LOST CREEK ISR, LLC

**Re: Annual Report of Changes, Tests, or Experiments Pursuant to License Condition 9.4(E)
Lost Creek ISR Project
License SUA-1598 Docket 40-9068**

Attachment 1: SERP Summary
2016 Annual Report of Changes, Tests, or Experiments
Lost Creek ISR Project SUA-1598

CURRENT SYSTEM

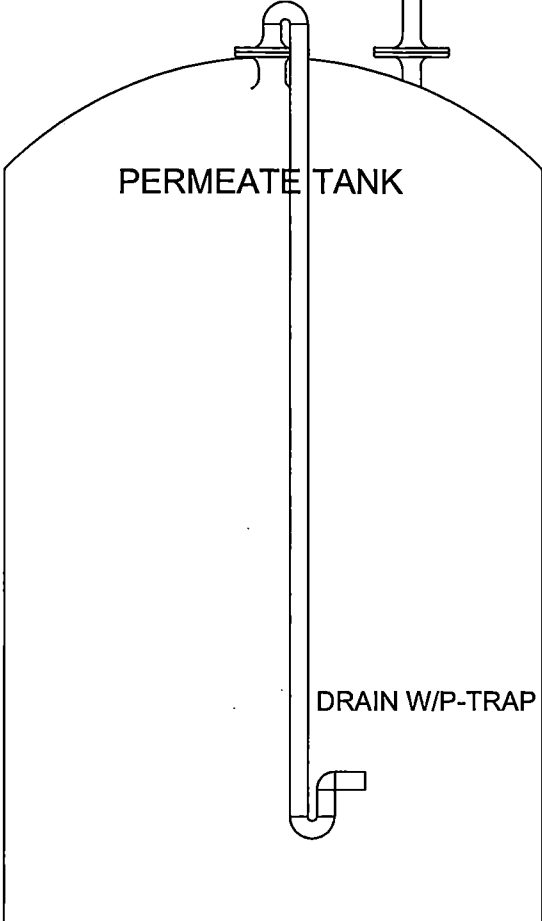
A SERP meeting was held on April 15, 2016 to discuss the alteration of the vent line connected to the Permeate Tank in the Plant. The engineering and planning was completed as ORC15-06. The Permeate tank vent was initially connected to the vent manifold connecting the elution circuit tanks to the final exit vent line. It was proposed that the vent line from the Perm Tank was to be isolated to prevent the possible contamination of permeate if the elution tanks were to overflow into the vent manifold. No booster fan would be installed in the line.

Since the overflow of the tanks was an issue leading to the design change, the flow rates into the tank were discussed as a worst-case scenario. The max flow of water to the tanks would be on the order of 720 gpm. The flow rates of air through the piping and the sizing of pipe was discussed. The sizing determinations/calculations were made as part of ORC15-06.

Radon was discussed. The design includes an overflow line with p-trap for preventing radon from emanating into the Plant area. It was discussed that if the flow rate was great enough would the p-trap design prevent water from being pushed out and liberating radon. Radon is still a concern since the RO system does not remove radon.

It was necessary for the SERP to approve a figure change (Figure 4.1-3) that shows the vent pipe schematic.

The modification to the vent line was approved by the SERP as well as the figure change in the TR. The change would be made to TR Figure 4.1-3. The SOP would need to be edited to include operation of the Perm Tank and precautionary information on radon.

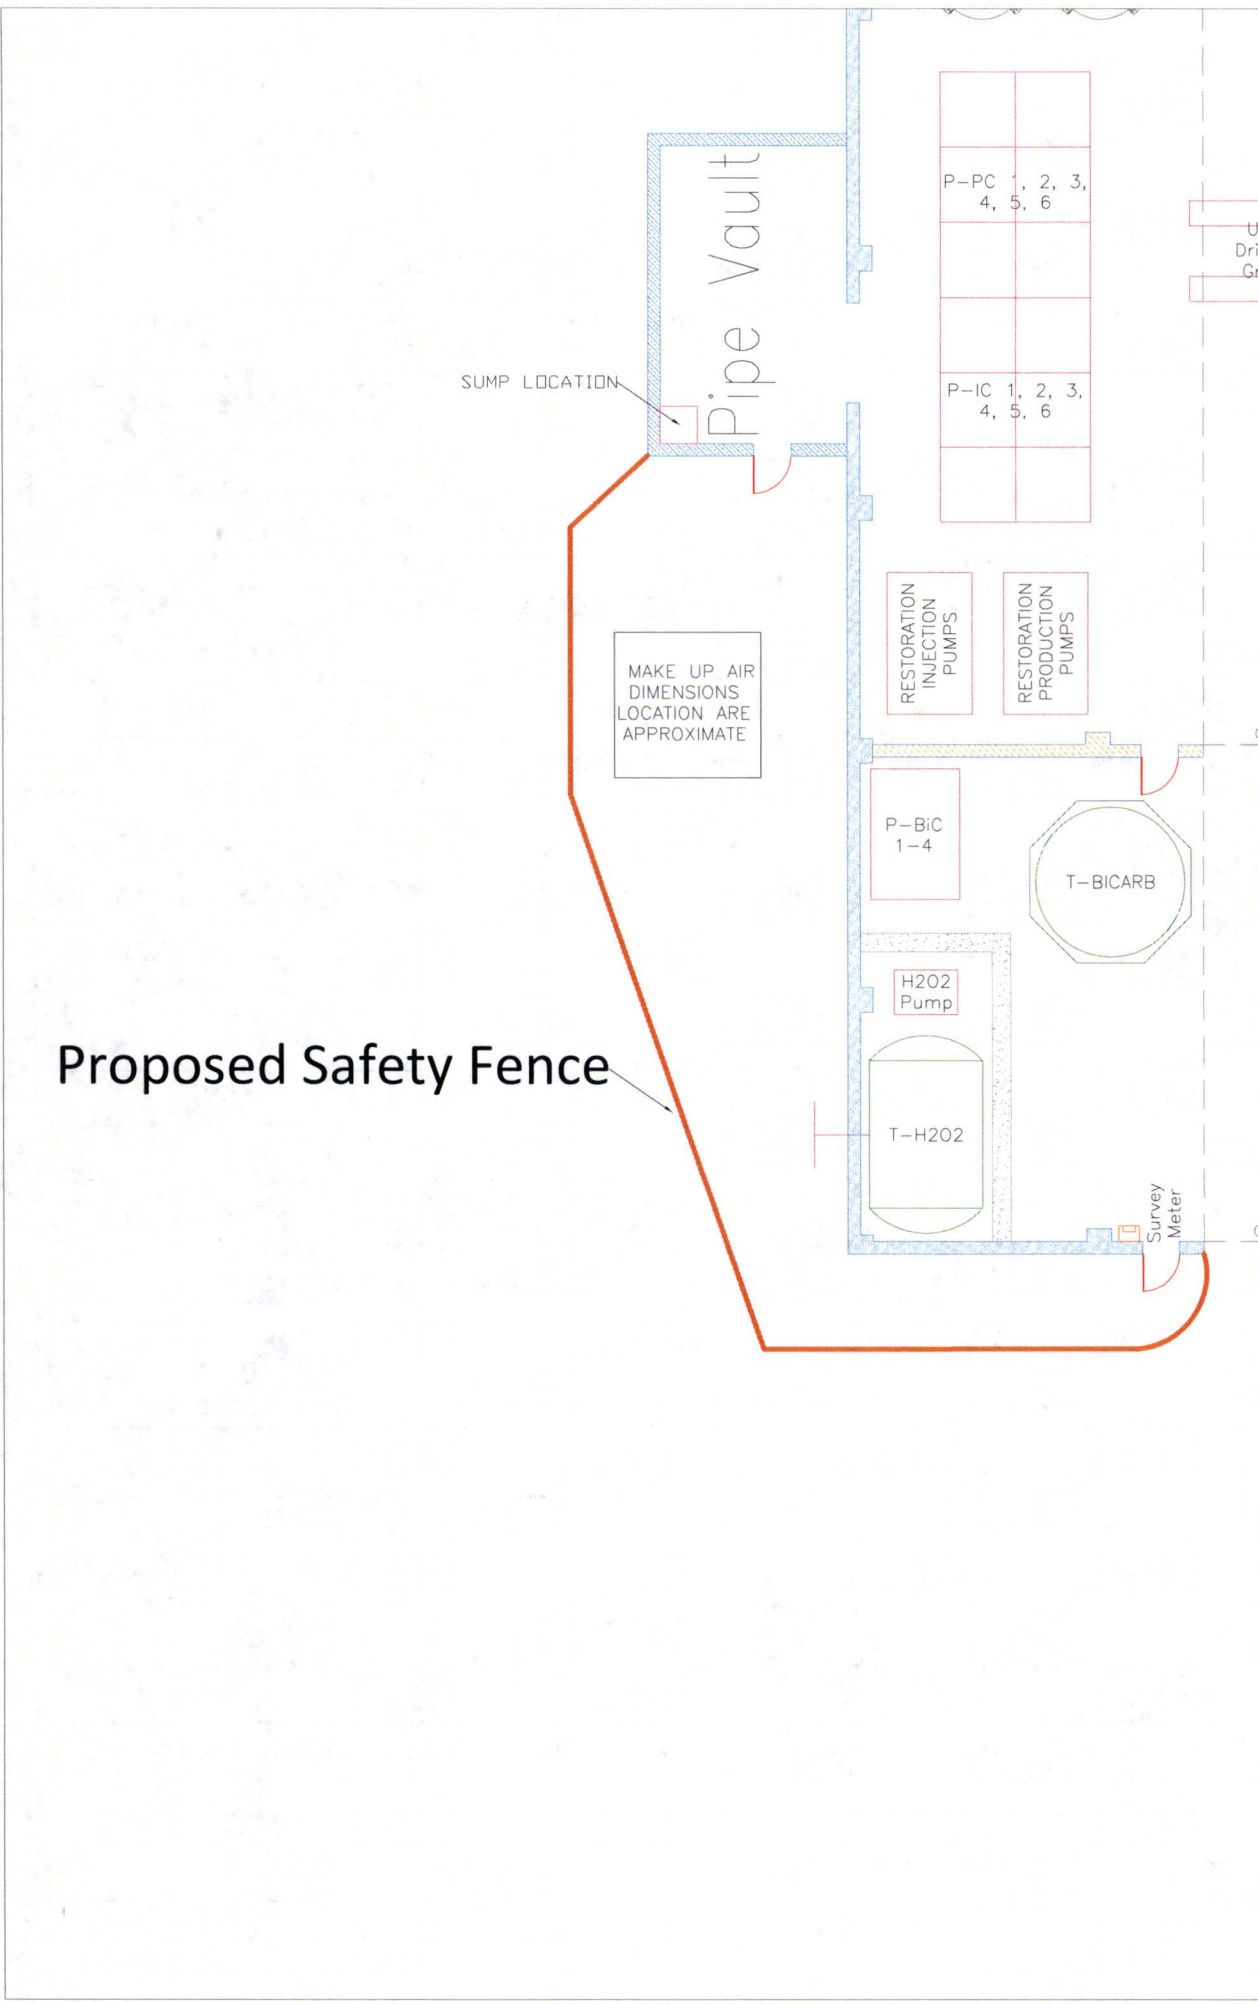
- Expansion of the RA Boundary
- Installation of fencing at the RA Boundary perimeter
- Installation of the new access door
- Changes to Figure 5.7-1 showing the delineation of the RA Boundary

- NEED TO MODIFY FIG 5.7-1 IN TR WITH ADJUSTED RA BOUNDARY
- PROVIDE TRAINING ON NEW BOUNDARY + INGRESS/EGRESS PROCEDURES -
- SERP APPROVAL INCLUDES UPDATES TO FIG 5.7-1 (ie sampling locs + AS BUILT CORRECTIONS)

Work as approved by this SERP has been suspended and not yet completed as of March 2017. Therefore, the Restricted Area boundary modification to Figure 5.7-1 in the Technical Report has not been made and will be included in the 2017 summary of changes if those changes occur. Additionally, changes to the procedures have not yet been made.

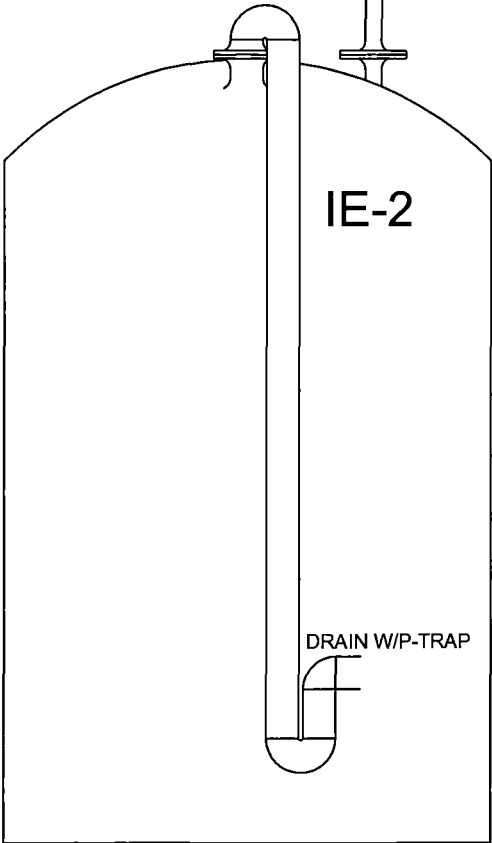
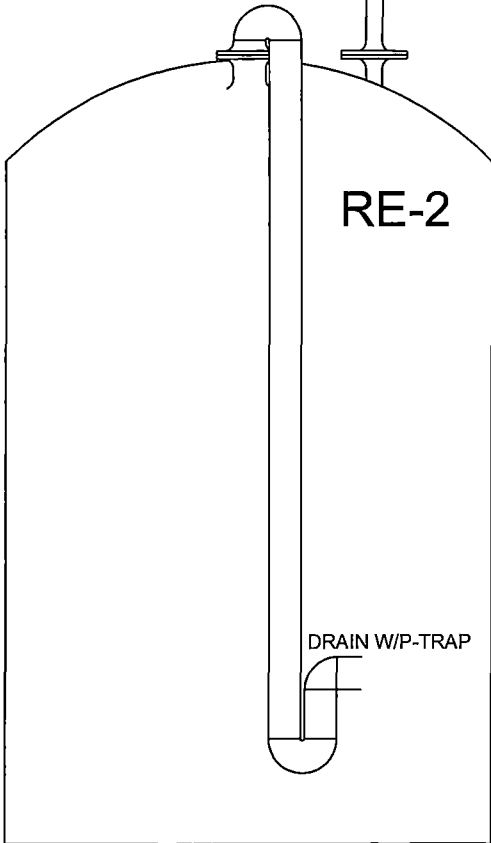
It was necessary for the SERP to approve a figure change (Figure 4.1-3) that shows the vent pipe schematic.

The modification to the vent line was approved by the SERP as well as the figure change in the TR. The change will be made to TR Figure 4.1-3.
